DSA 810 LOCAL FIRE AUTHORITY REVIEW

Project Name/School: Fremont Elementary School

FIRE ACCESS SITE PLAN

F0.1

1 FIRE ACCESS SITE PLAN

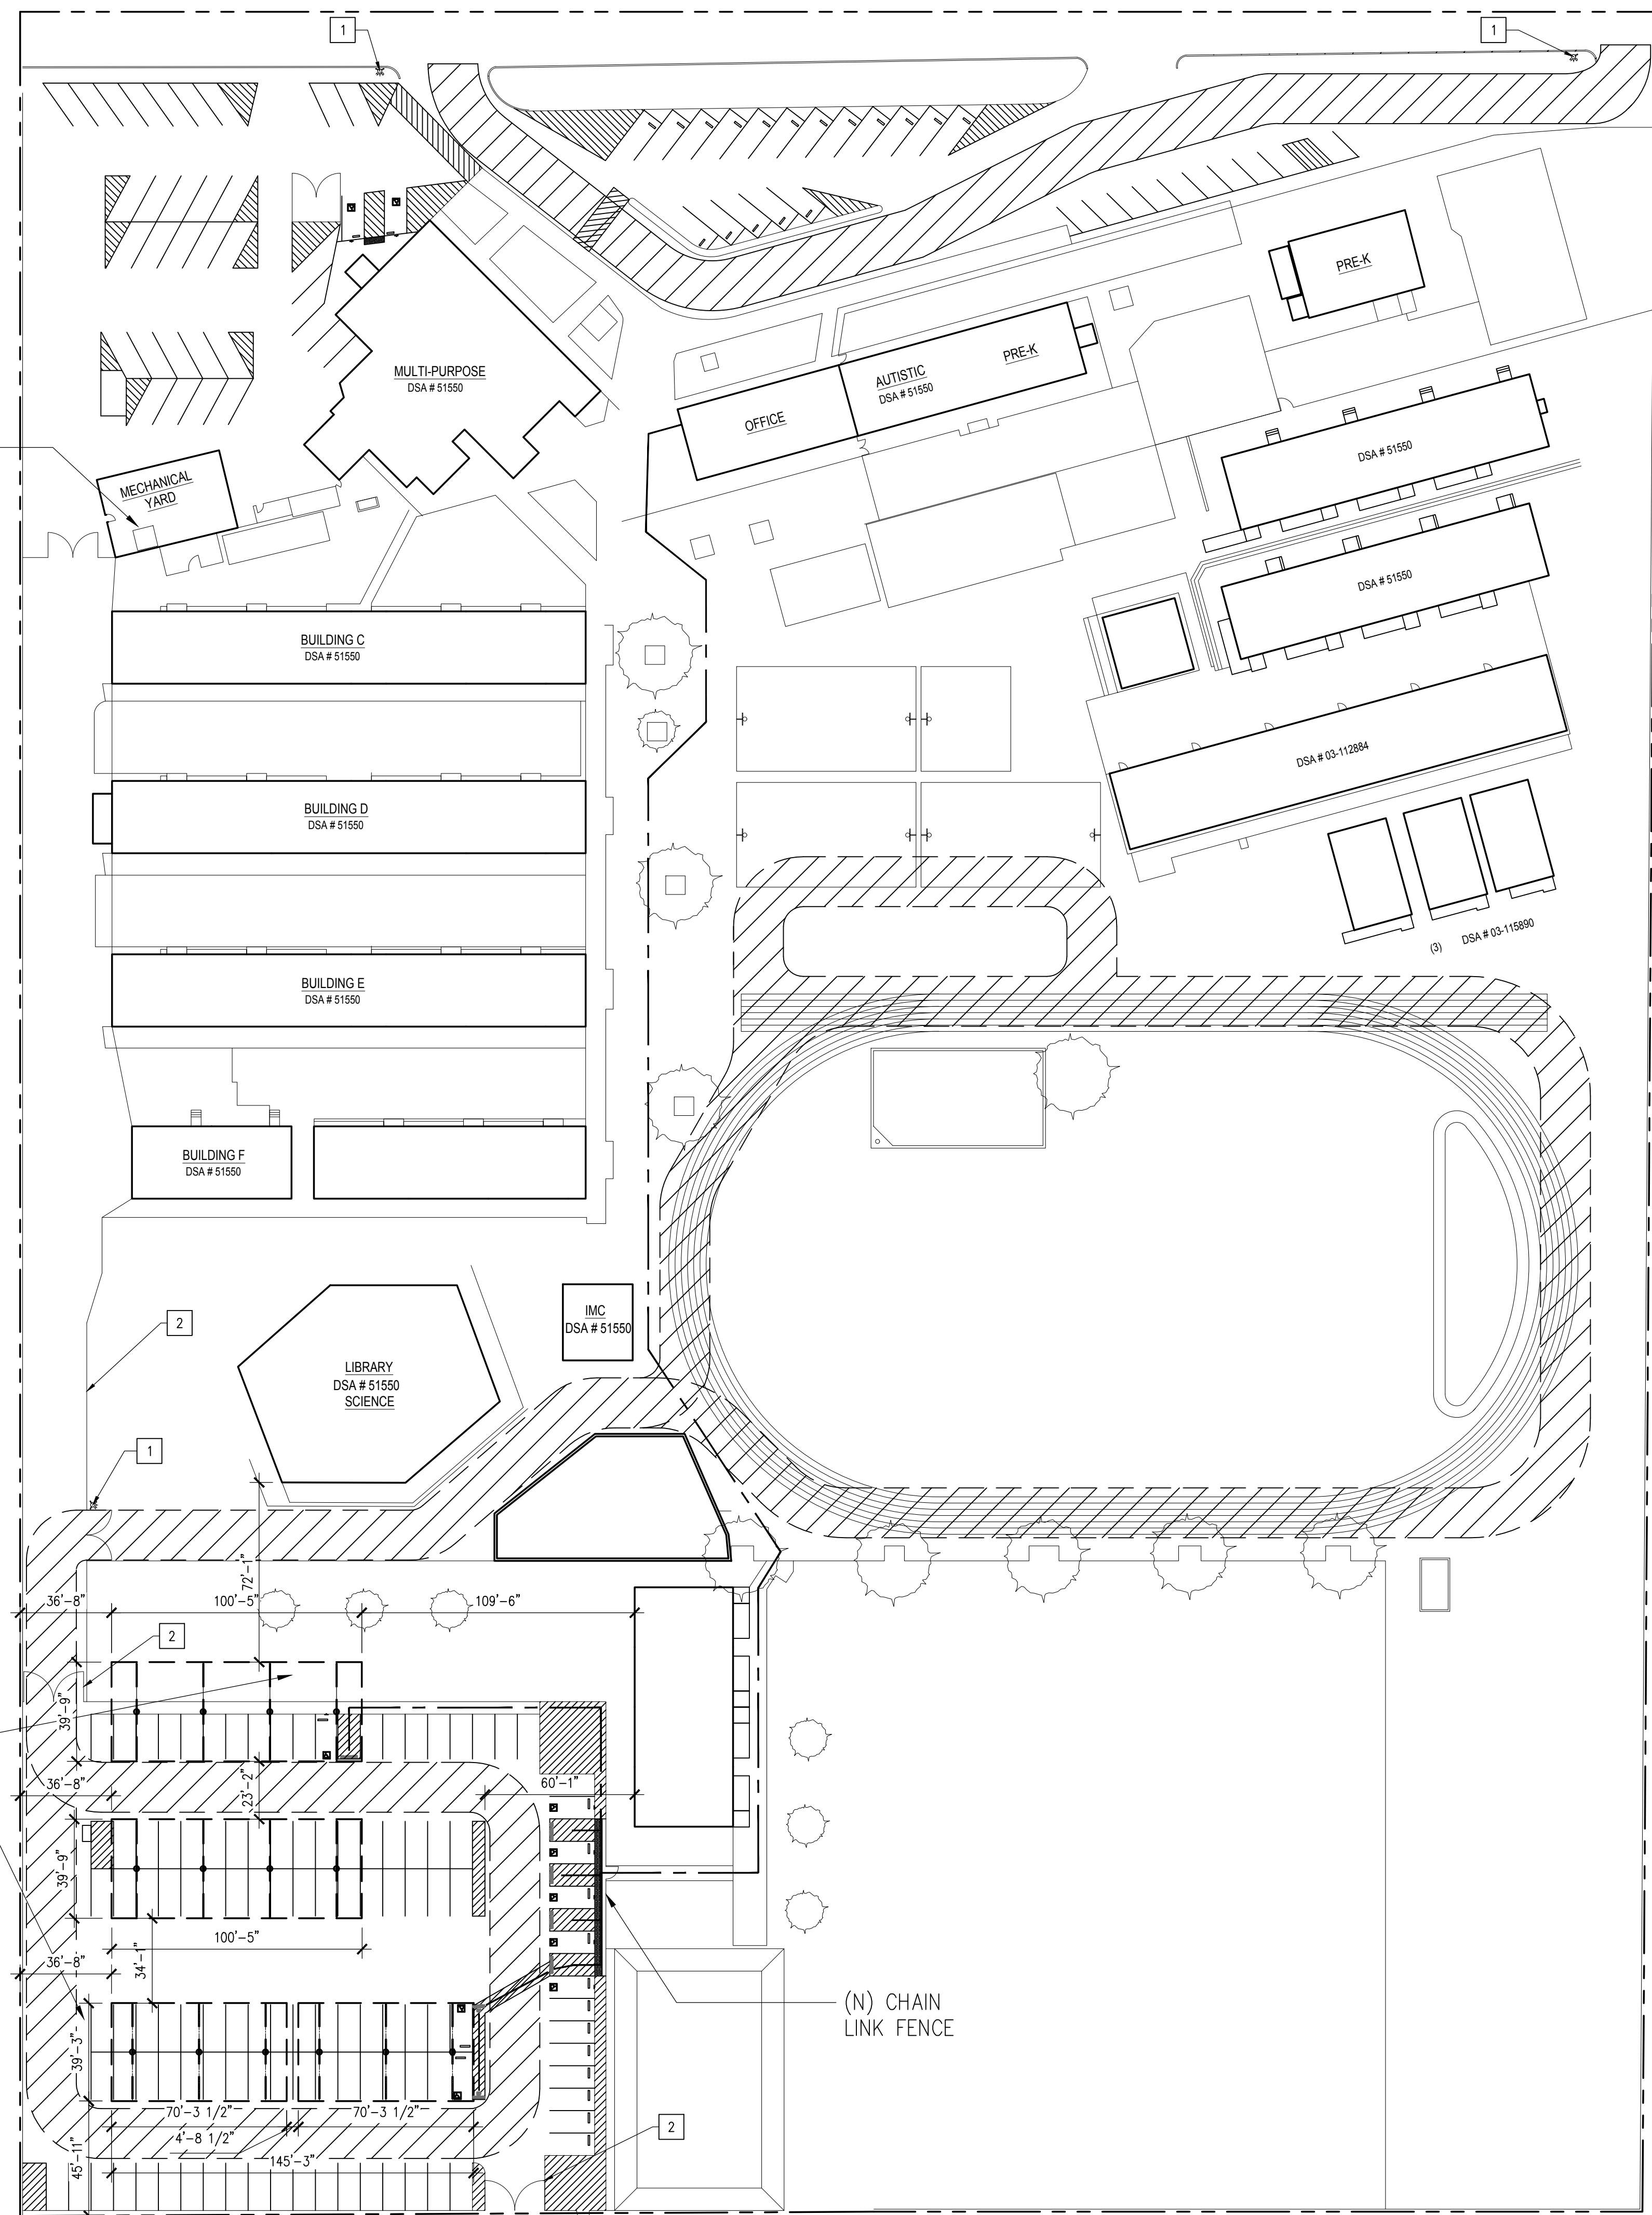
6	The location(s) of the detector check valve assembly meet the requirements of this jurisdiction.				X
7	Is the project located in a hazard severity zone area? (CBC, Chapter 7A, Section 701A.) <input type="checkbox"/> Yes <input checked="" type="checkbox"/> No				
Check type if "Yes": <input type="checkbox"/> Moderate <input type="checkbox"/> High <input type="checkbox"/> Very High <input type="checkbox"/> WIFA (If one of these boxes is checked, the project design must meet the requirements of Chapter 7A.)					
8	COMMENTS (note deficiencies): <u>PLEASE MAINTAIN 13.6 FT. MIN. ON LOW END HEIGHT FOR FIRE ACCESS.</u>
